# Certificate of Appropriateness—Amended

910 N. OLD WORLD THIRD ST. Second Ward Savings Bank

1/11/2017 Amended 11/9/2017

PTS ID 114186 COA

Drawing No.  
A301

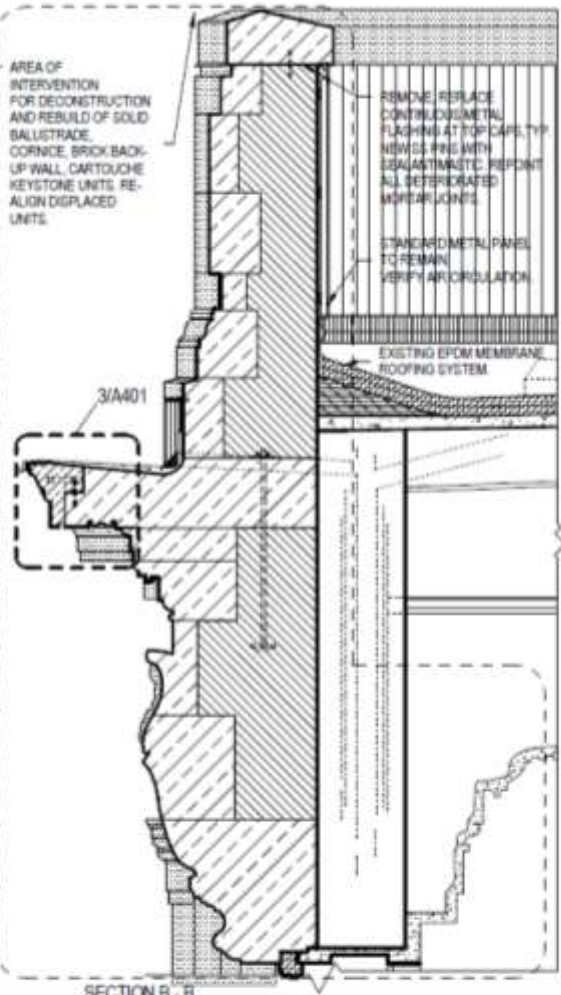
The stone cladding of the solid balustrade will be re-pointed. The previously mortar-set cap stones will be pinned and have new, alloy-coated copper flashing. The balustrade brick back-up walls are protected by metal panels installed on hat channels. Air circulation was verified and so the existing metal panels will remain in place. (1/A301)

The re-alignment of the most displaced limestone cartouche will necessitate the complete deconstruction and rebuild of the wall's full-depth including the solid balustrade above. An assessment of the conditions necessitating the displacement will inform the subsequent stabilization of at least four of the remaining six cartouche assemblies. (Total of seven cartouche.) Alternatively, given that the assembly works as a true arch, a repair-in-place is feasible. Approximated life-span is 25 years. The visual displacement would remain. (1/A301)

WORST-CASE CONDITION AT ONE OF SEVEN CARTOUCHE LOCATIONS KEYSTONE UNITS SHIFTED DOWN AND OUT OF PLANAR ALIGNMENT.

Drawing No.  
A302

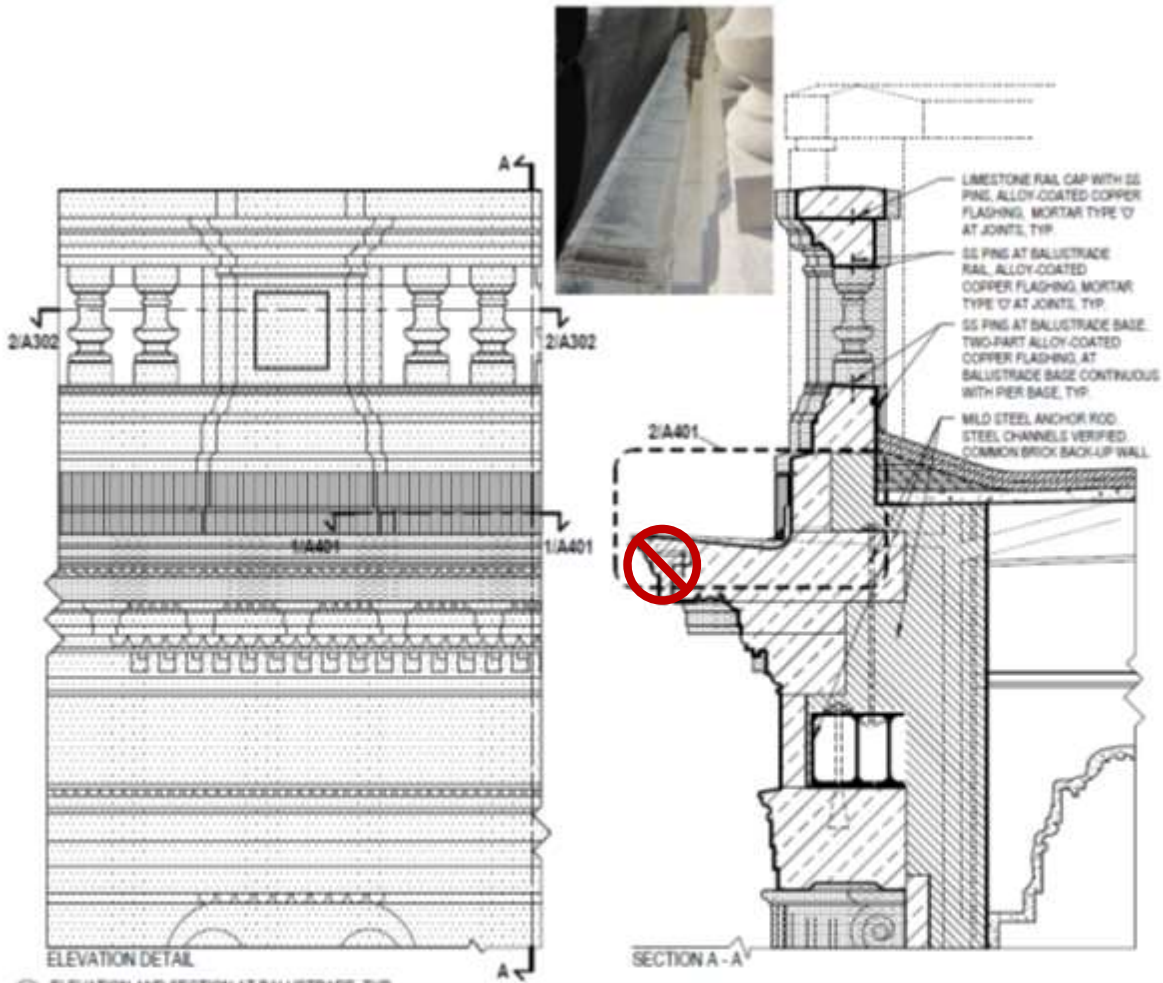
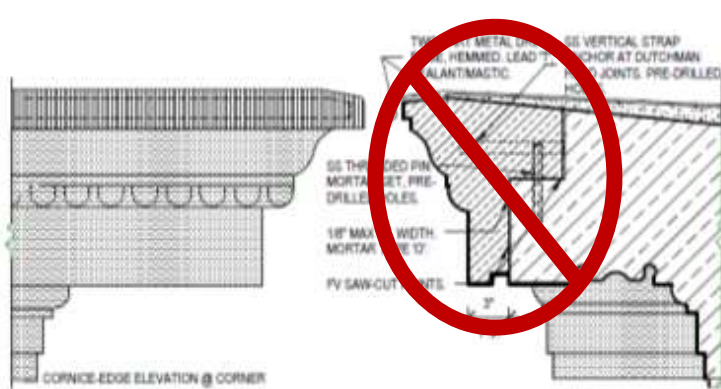
balustrade cap stones and baluster base units (plinth). (1/A302)

Repair details. Disregard repair to cornice. This has been revised. Flashing and gutters remain as shown.

A401

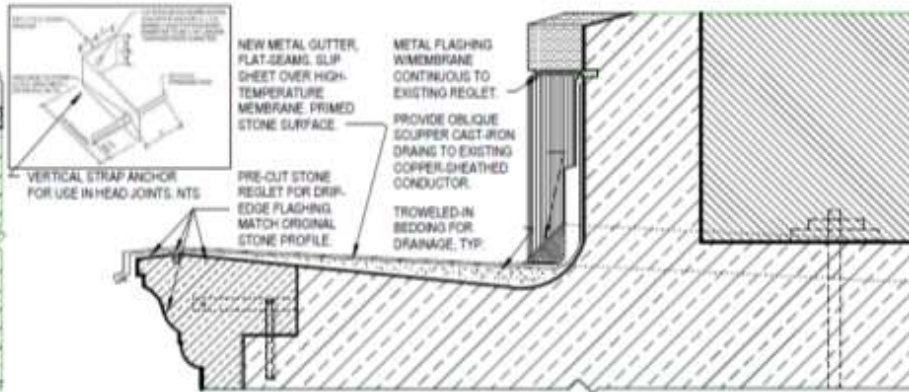
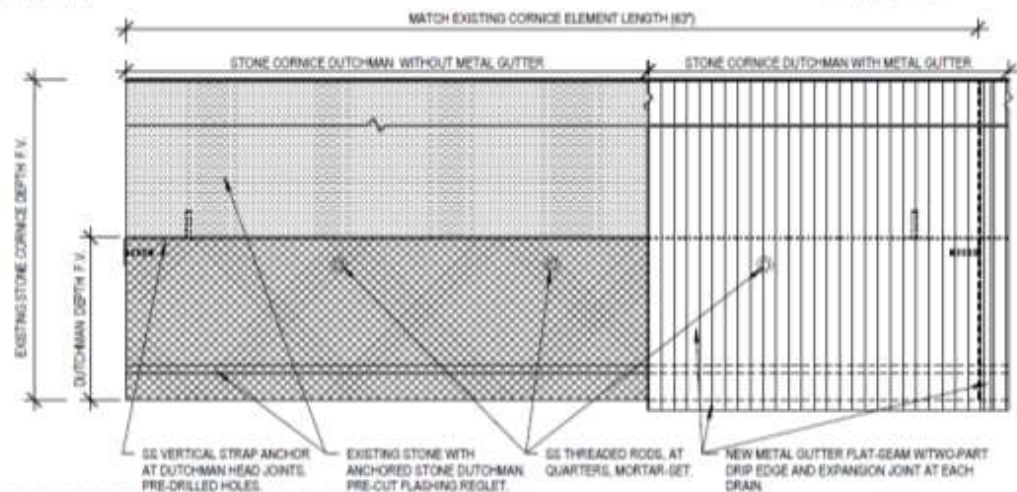
The existing flashed-in cornice conductor opening will be replaced by sidewall drains to assure efficient drainage. The carved limestone units, below the projecting cornice, will be cleaned of all efflorescence and accumulated dirt and grime. (2/A401)

An alloy-coated copper gutter, flat seamed, will line the entire stone projection from the drip edge to the up-wall flashing. Expansion joints will be installed at the six drain locations. A watertight membrane and complete repointing of the cornice mortar joints will inhibit water infiltration into the wall assembly below. (1/A401)

Repair details. Dutchman repair shown at top of this page shall be performed differently per further information below. Flashing and gutter details remain as shown.

## Glossary of Terms – Limestone Units

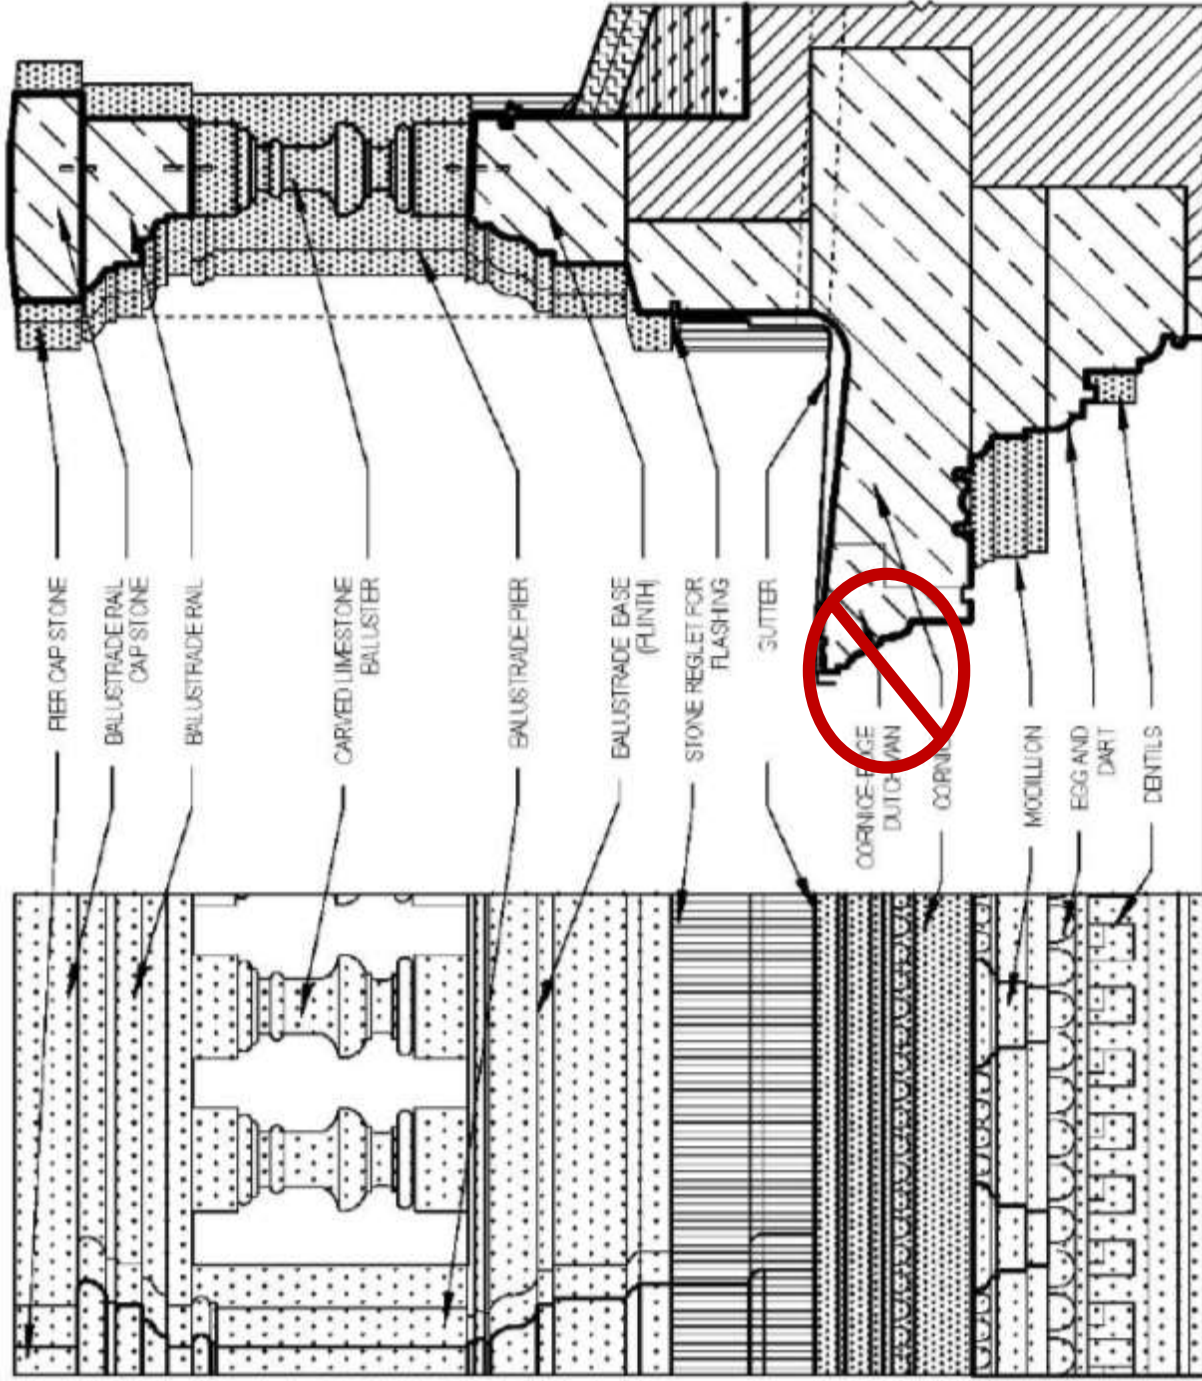
Dutchman repair of cornice shall not be performed as on this page. Revised methods are on the following pages.

④ CORNICE EDGE DUTCHMAN CONNECTOR SECTION  
3" = 1'-0"

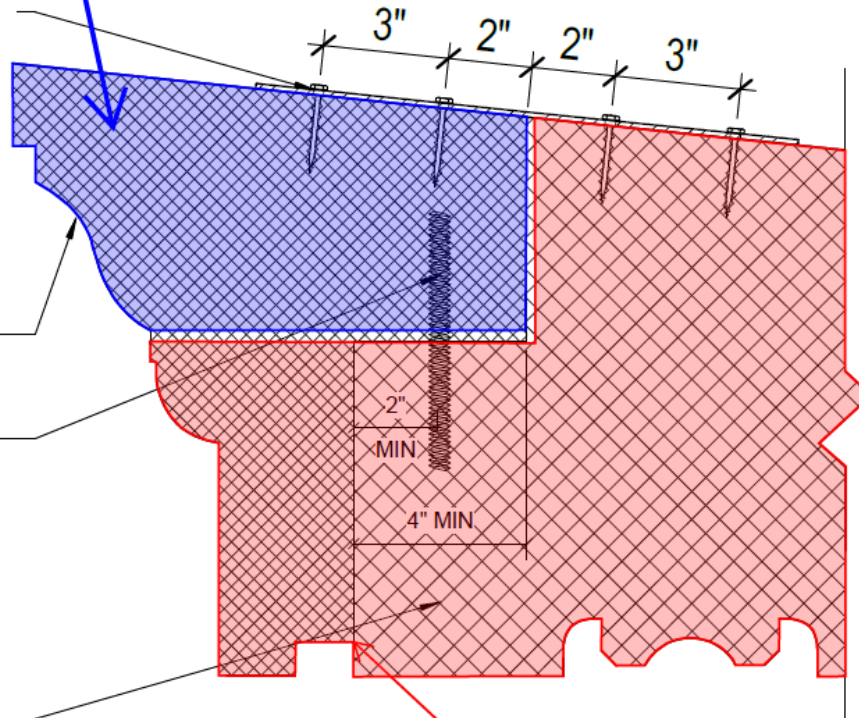
Revised repair method for cornice.

REVISED DUTCHMAN:  
DAMAGED CORNICE GUTTER EDGE  
TO BE REMOVED AND REPLACED  
WITH LIMESTONE DUTCHMAN.

REVISED DUTCHMAN EDGE PERMITS THE  
ORIGINAL FEATURES, EGG & DART AND  
CORDUROY FINISHED STONE FACING, TO  
BE RETAINED.

1 1/2" x 20ga STAINLESS  
STEEL STRAP AT 1/4 POINTS  
w/ (4) 1/4"dia STAINLESS  
STEEL ELCO AGGREGATOR  
CONCRETE ANCHOR w/ 1 1/2"  
MIN EMBED, (2) EACH SIDE.  
SINK STRAP FLUSH WITH  
TOP OF STONE AS  
REQUIRED TO INSTALL NEW  
GUTTER FLASHING  
NEW DUTCHMAN  
REPAIR

1/2"dia x 6" STAINLESS  
STEEL THREADED ROD  
CENTERED ON JOINT.  
MORTAR-SET IN PRE-  
DRILLED HOLES
